## Asylum Follow Up - jmb@portlandmaine.gov - City of Portland Mail

**Subject:** Asylum Follow Up

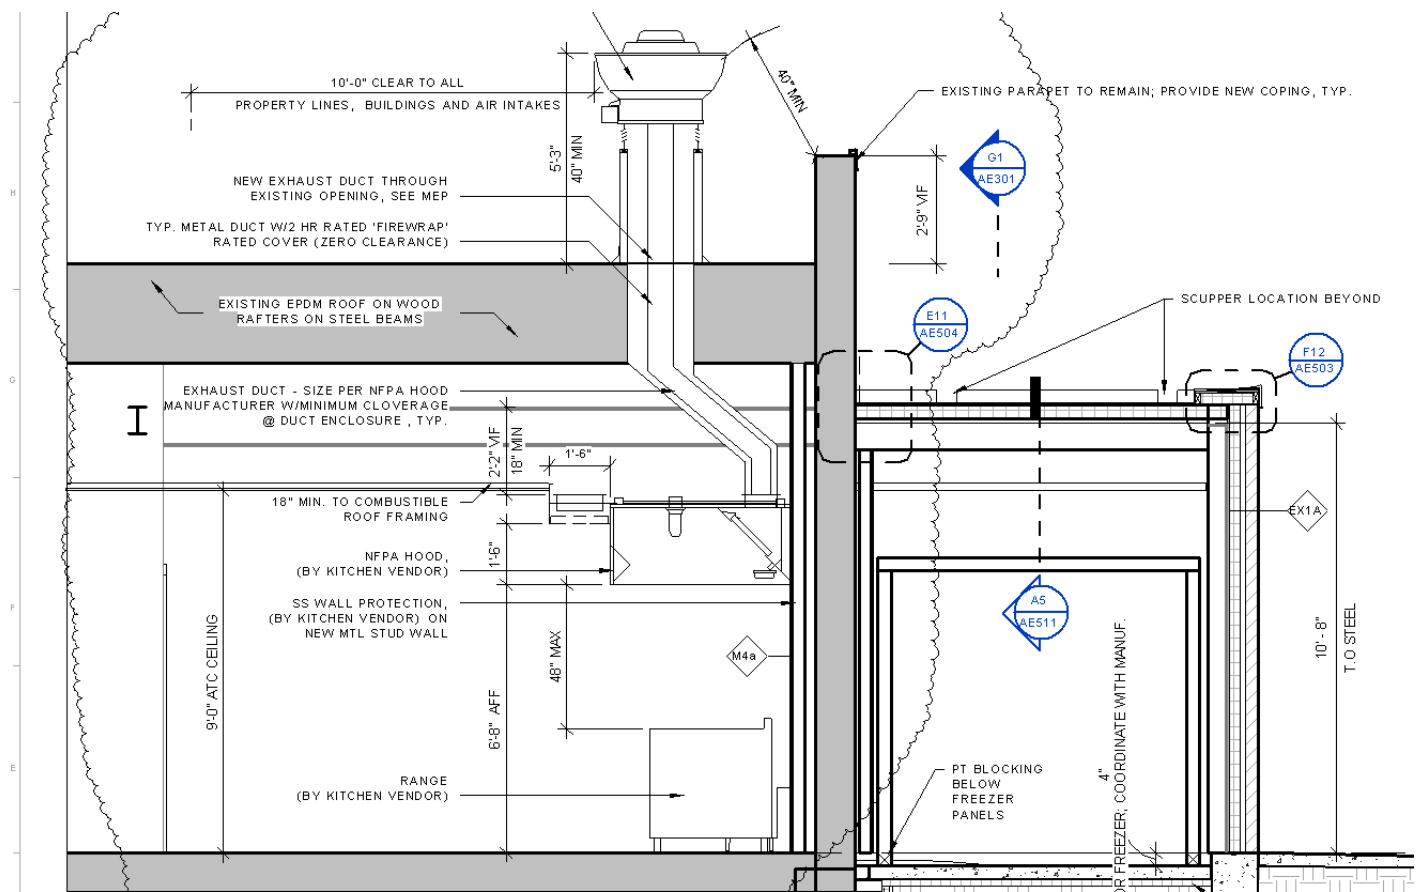
I wanted to follow up our discussion yesterday on the substrate behind the new kitchen hood. I have attached the associated NFPA 96 reference passages with the appropriate sections highlighted as well as a cut sheet of the specified ceiling tile. We will be replacing the wood furring wall behind the hood with a new metal stud wall with 5/8" type X moisture resistant gypsum wall board. This wall will be classified as a limited combustibile wall, which requires the 3" hood standoff which is included in the hood design. The hood will be more than 18" from the existing combustibile wood frames rafters, and the new ceiling will stop before the hood and is also listed as Fire Class A/FireGuard material. Please see the updated diagram below for reference.
